87-LES-27

NRC DRAFT SITE TECHNICAL POSITION, DOE HIGH LEVEL WASTE REFERENCE REPOSITORY LOCATION, HANFORD SITE, "USE OF HYDRAZINE TO EXPERIMENTALLY SIMULATE EXPECTED SITE REDOX CONDITIONS AND REACTIONS"

NRC DSTP ON THE "USE OF HYDRAZINE TO SIMULATE HANFORD SITE REDOX CONDITIONS AND REACTIONS"

Pb(II) Sorption on Cohasset Basalt

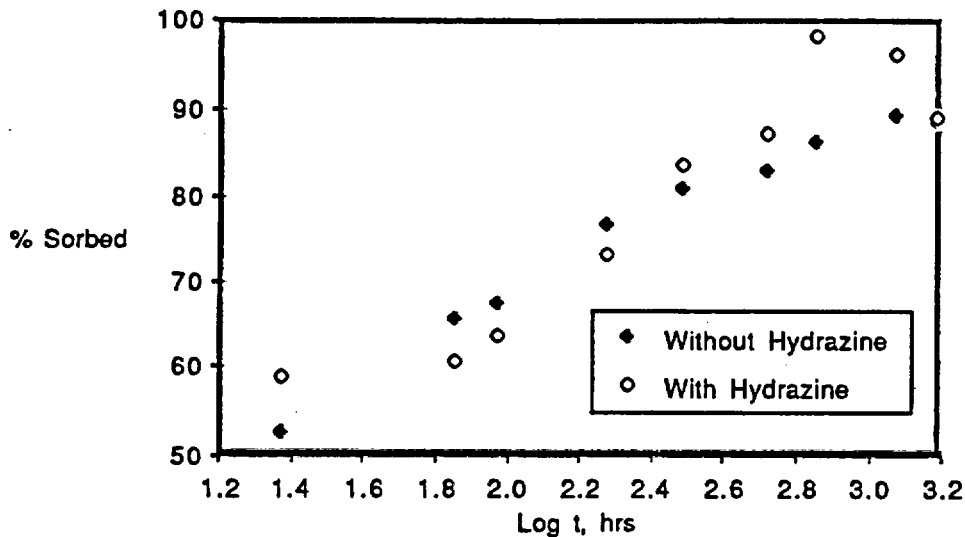
Statistically designed measurements of Am sorption on basalt, secondary minerals, and several interbed materials (sandstone and tuff) by Barney (1981 and 1982) show that there is no significant difference in sorption whether or not hydrazine is present. Because hydrazine will not react with Am(III), any interference effects of hydrazine with the sorption process would show up as different sorption behavior when hydrazine is present. Since no differences are observed, it is concluded that hydrazine does not interfere with sorption. Because other radionuclides that are reduced by hydrazine will likely sorb by mechanisms that are similar to Am(III) sorption (complexation with oxygen ligands on the mineral surface), hydrazine will not interfere with their sorption either. The sorption behavior of Pb(II) and Zr(IV), neither of which is reduced by hydrazine, is not altered by the presence of hydrazine (Ames, 1983) as shown in the following plots:

These plots show that the percentage of Pb(II) or Zr(IV) sorbed at a given time is not dependent on the presence or absence of hydrazine (within experimental error).
